1 October 2025

## **WASTE MANAGEMENT NZ LIMITED – FAIRFIELD CLOSED LANDFILL APPLICATION (RM24.098) RESPONSE TO TECHNICAL REVIEWS**

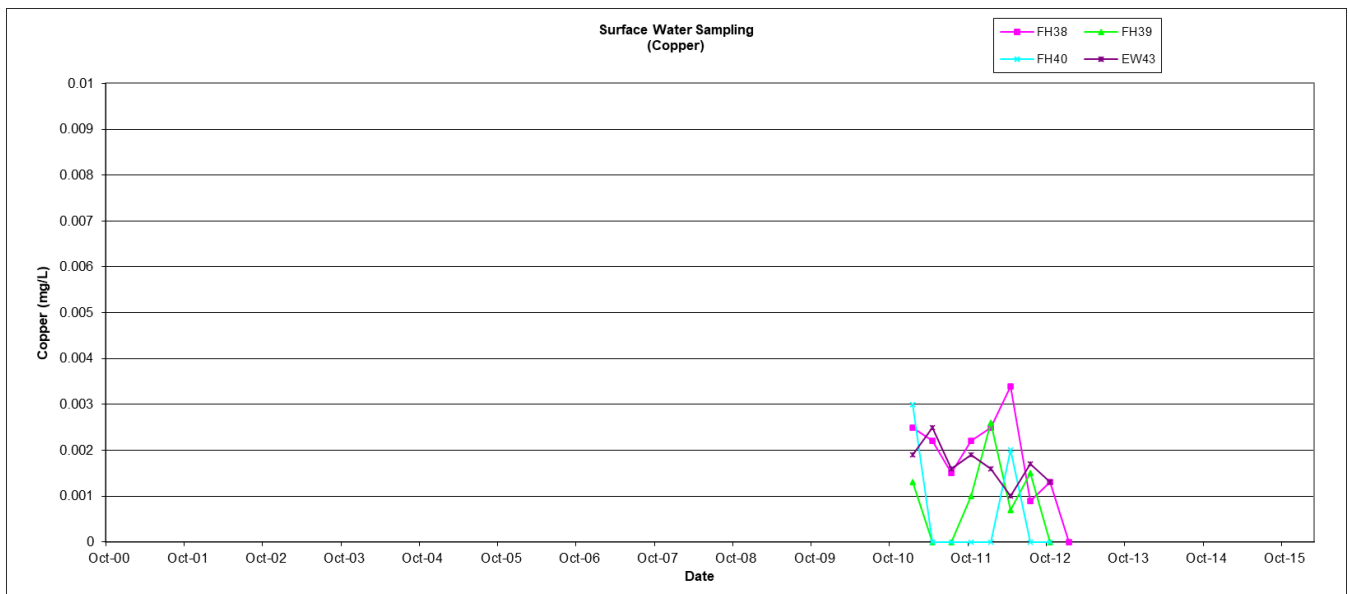
The author has recommended that copper should be included in the parameters tested for surface water monitoring. Copper was included into the surface water sampling analytical suite between 2011 and 2012 as a result of copper being identified as being present within the leachate at concentrations exceeding the

ANZECC 2000 guidelines. Sampling results showed non-detectable to low dissolved copper concentrations up to 0.003 mg/L (FH40) (see plot below). Comparison with the ANZECC 2000 guidelines for marine and fresh water (adjusted using the hardness-dependent algorithm for fresh waters) shows acceptable concentrations for 95% level of protection of all species at all four sampling locations. On the basis of these results, copper impacts did not appear to be present in the surface water bodies associated the landfill activities, so copper was removed from the analytical suite. The inclusion of copper into the sampling suite of parameters for the period of time (over and above the consenting monitoring parameters) is an example of how an adaptive monitoring programme can be implemented which is modified based on data being obtained to support the assessment of risk to the environment.
